**From:** [Dan Grove](#)  
**To:** [Molly McGuire](#)  
**Subject:** Existing Grade for permit 2207-019 SUB3  
**Date:** Friday, June 9, 2023 9:00:14 AM  
**Attachments:** [2207-019 Existing Grade - for SUB3.pdf](#)

I'd like to submit this document to provide enhanced information on the Existing Grade of permit 2207-019 SUB3.

Molly McGuire  
Mercer Island Community Planning and Development Department  
RE: Permit 2207-019 SUB3 / 6950 SE Maker Street  
Jun 9, 2023

Figure 6. Overlay of 2004 Survey of the paved portion of Maker with contours from 1963 Survey

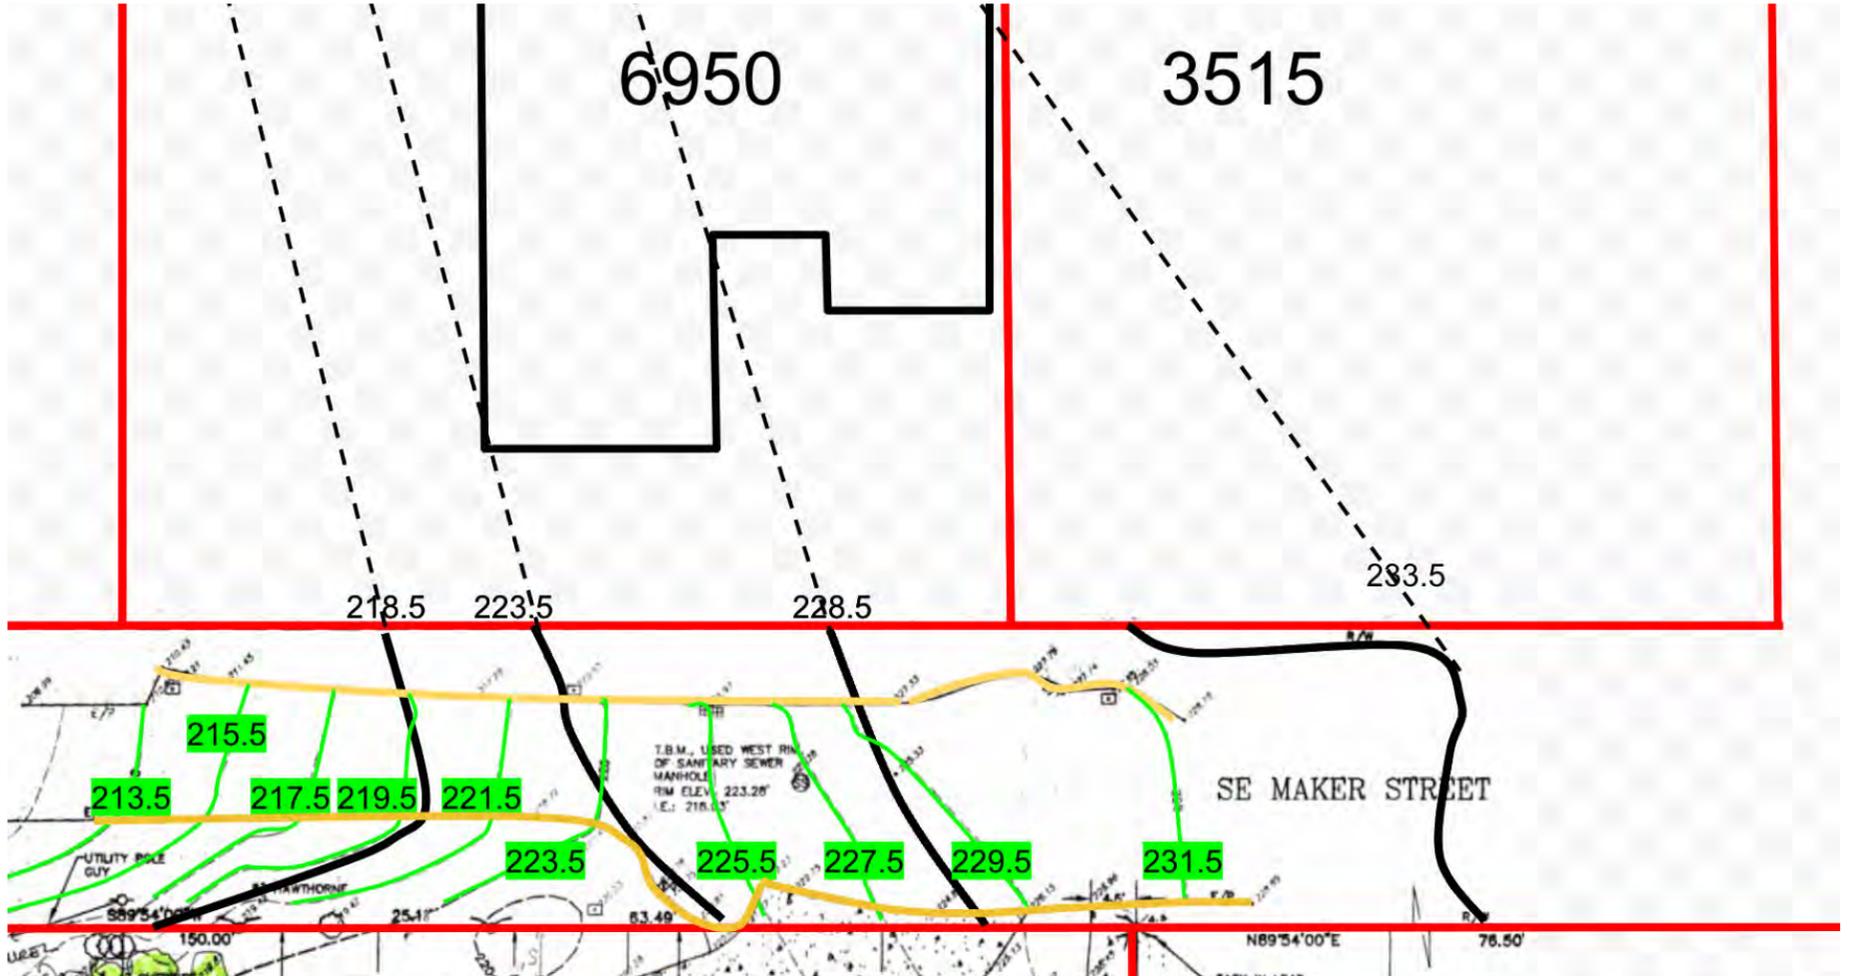
Between 1963 and 2004, Maker was paved (in 1965) and the rockery was built. It's clear that the elevation of the paved portion of Maker (surveyed in 2004, and shown in Green in Figure 6) didn't change appreciably from its 1963 elevations (in Black).

Note that the 2004 survey did not include the rockery - it only went as far north as the northern edge of the pavement on SE Maker Street.

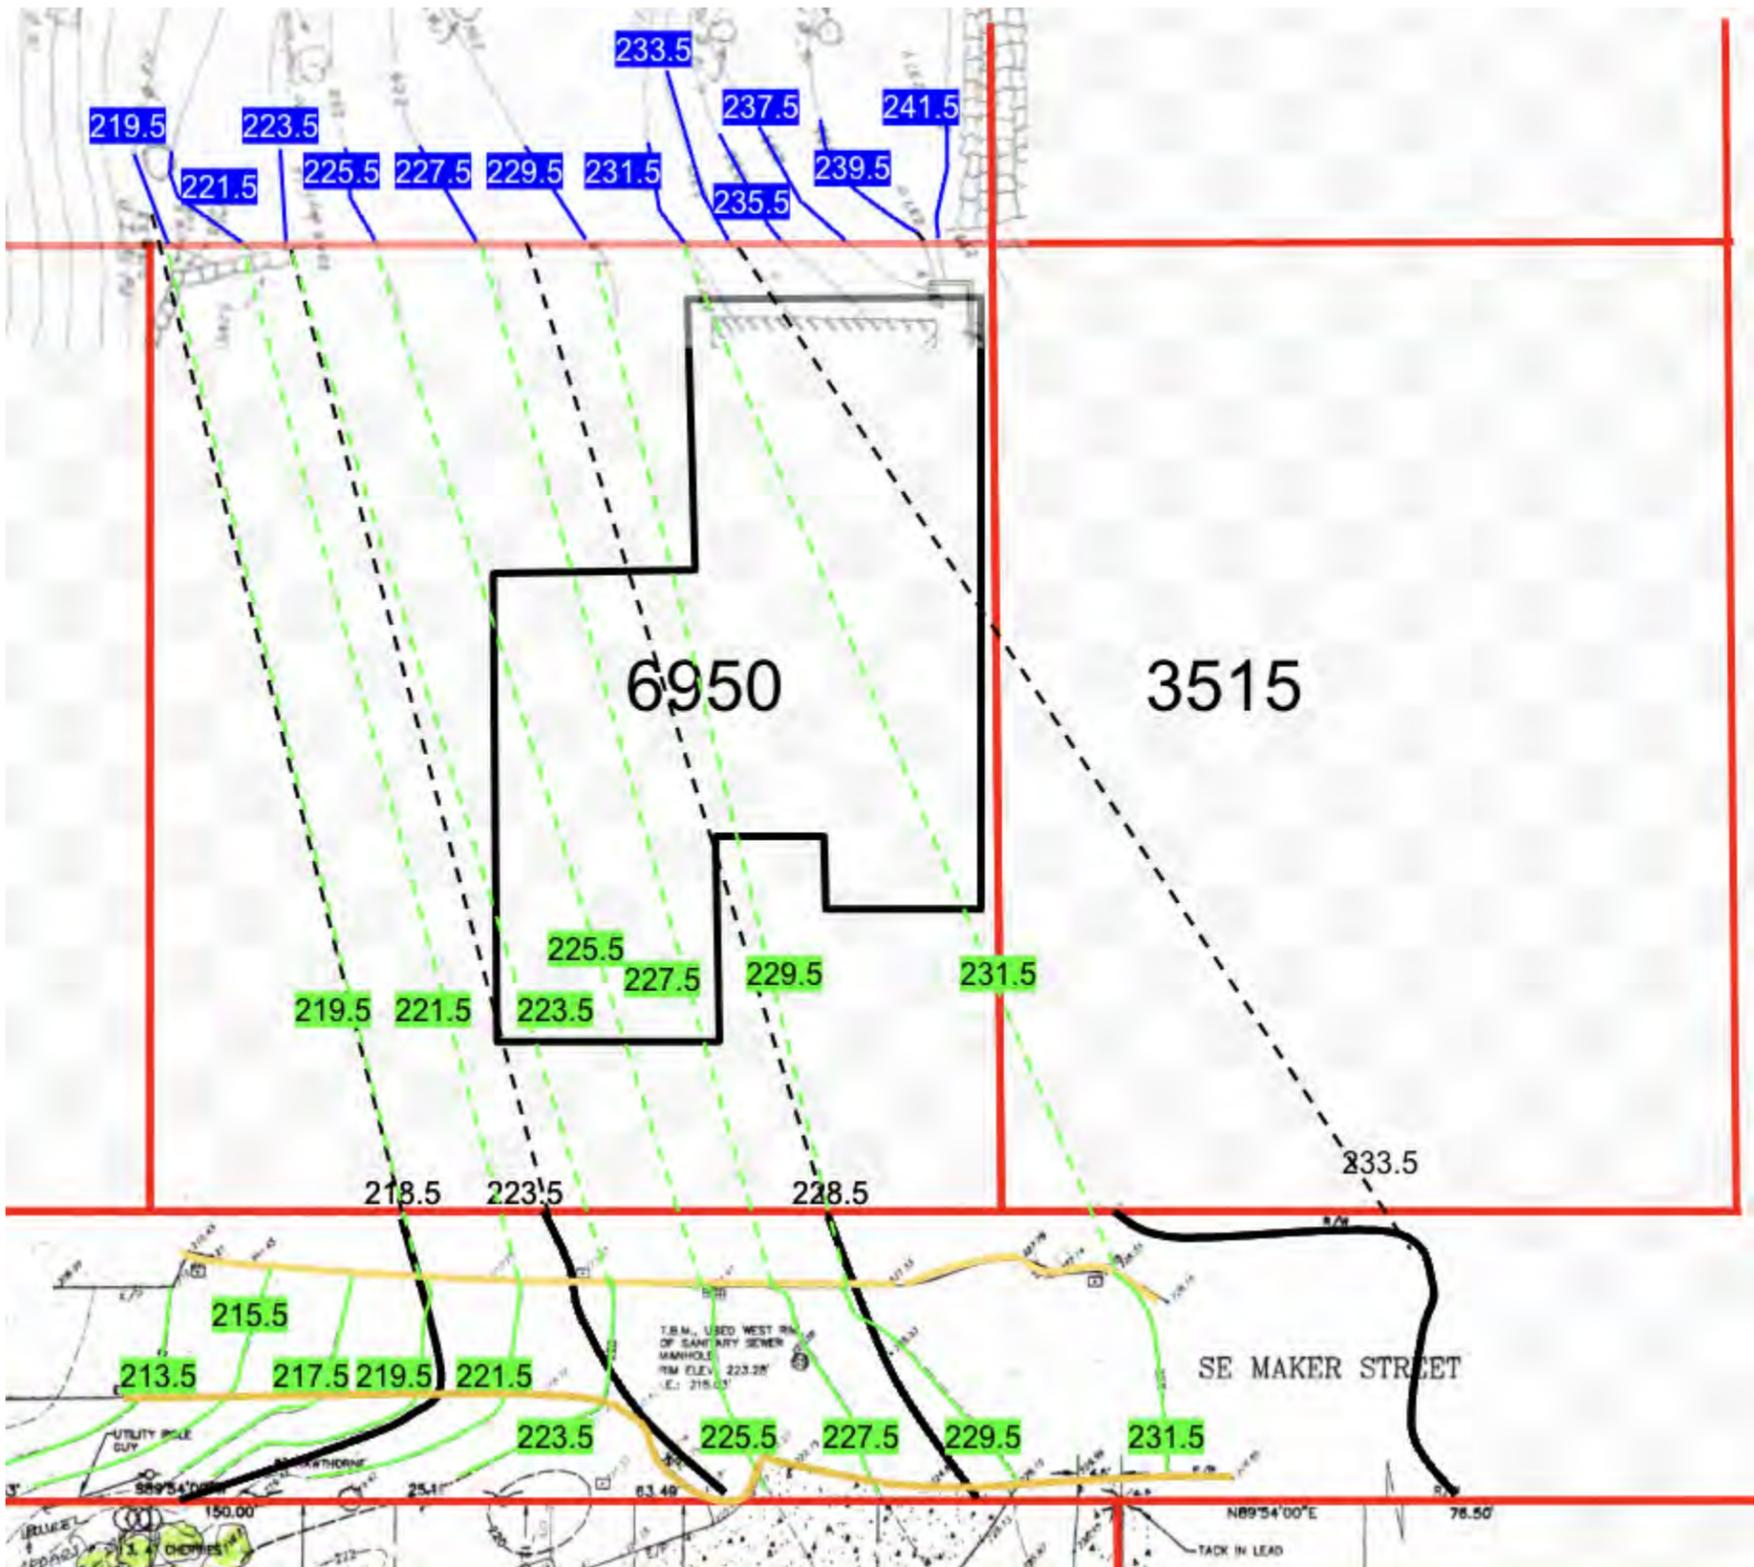
In Figure 7, interpolation based on both the 1963 Survey and the 2004 Survey shows that a near perfect match between the two sets of interpolated contours (Dashed Black Lines are interpolated based on the 1961 Survey, Dashed Green Lines are interpolated based on the 2004 Survey).

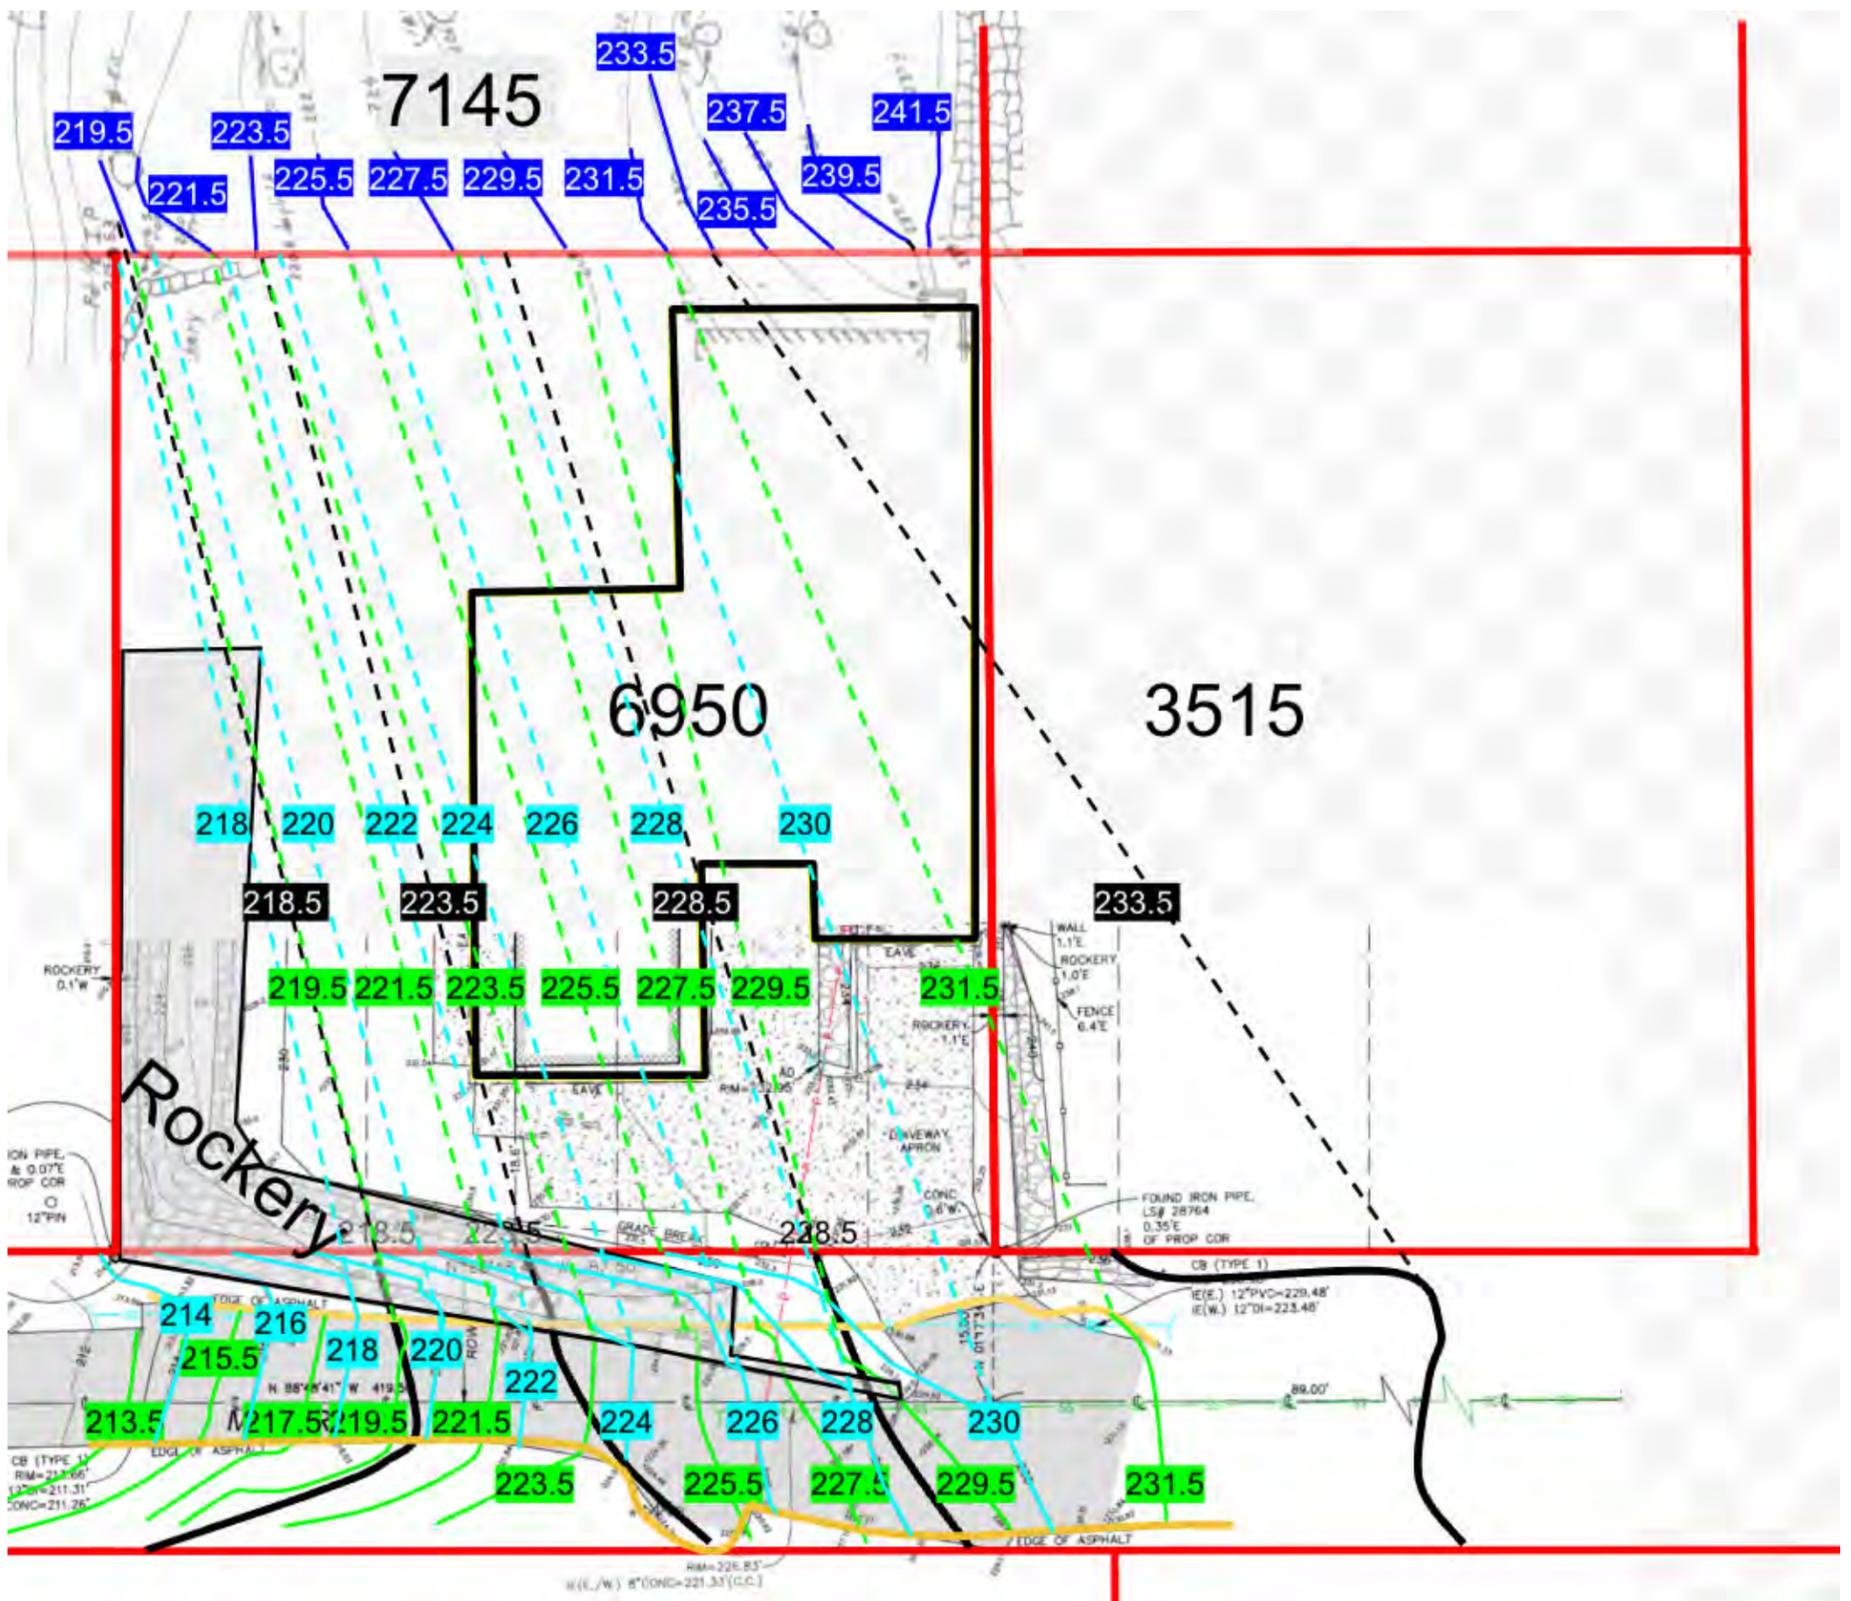
Shown in Figure 9, the 2021 Survey allows for more interpolations (Black Dashed Lines based on the 1963 Survey, Green Dashed Lines based on the 2004 Survey, and Cyan Dashed Lines based on the 2021 Survey). The degree to which these interpolations match is unmistakable.

Figure 10. Interpolated contour lines based on 1963 Survey, 1989 Survey, 2004 Survey, 2021 Survey, and current LIDAR.

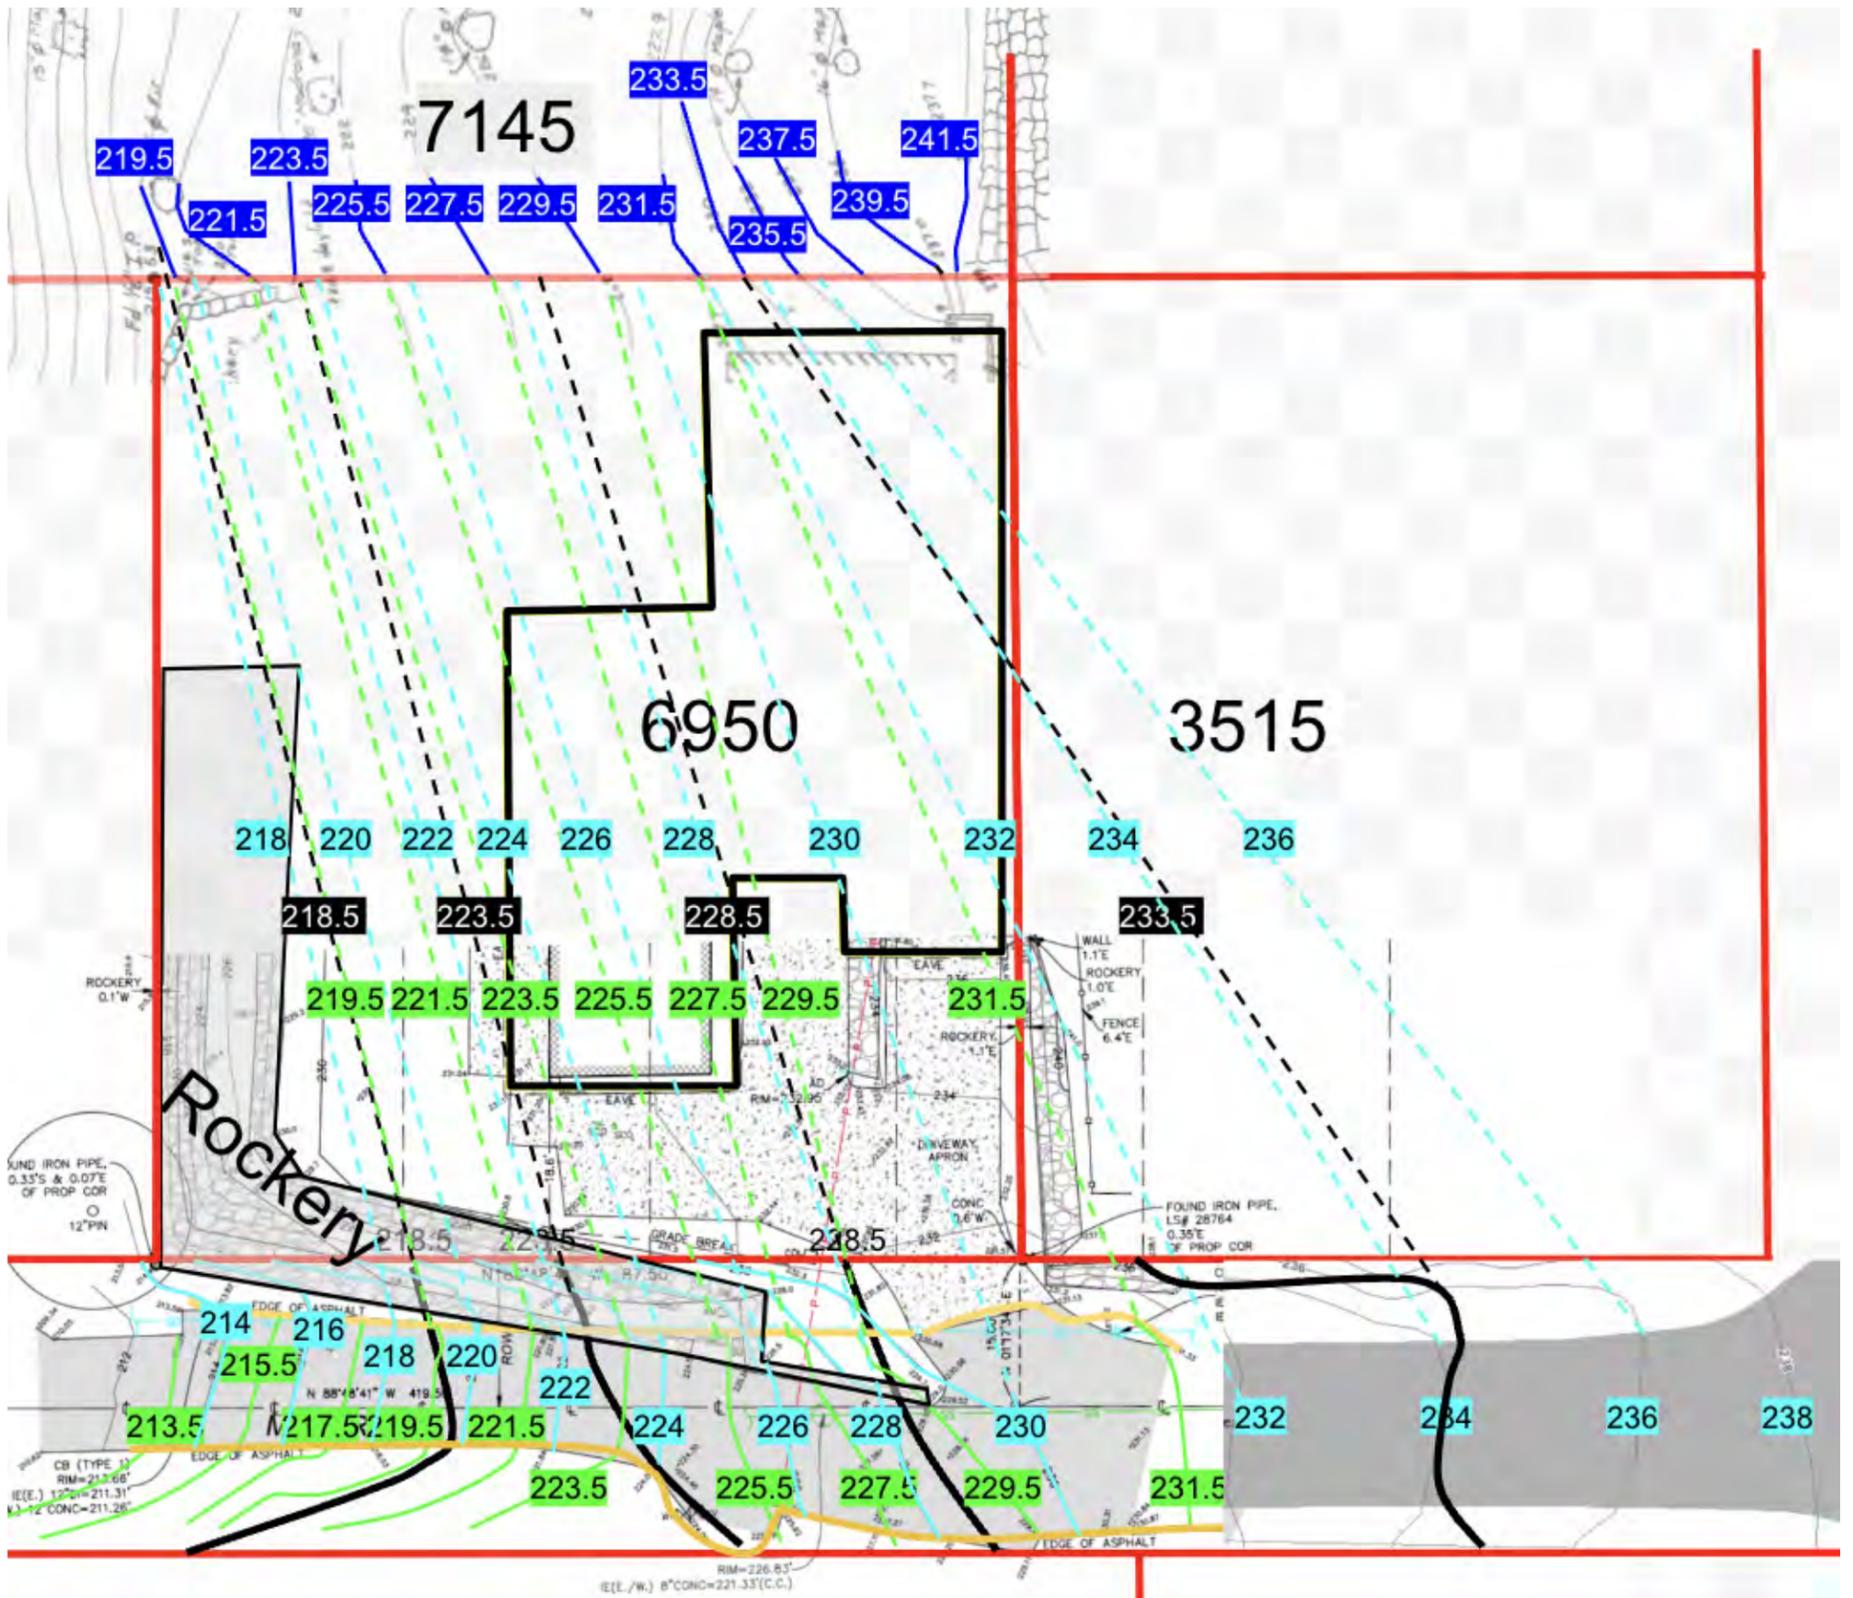
Finally, we can add in the latest LIDAR data to capture original contours of SE Maker southeast of 6950 (Black Dashed lines based on the 1963 Survey, Green Dashed Lines based on the 2004 Survey, and Cyan Dashed Lines based on the 2021 Survey and LIDAR data for the eastern end of Maker Street). These interpolations are shown in Figure 10.

The interpolated contours based on all of these surveys and LIDAR data reach the same conclusion: the 6950 lot was extensively Altered, and it is straightforward to determine the Existing Grade of the lot.
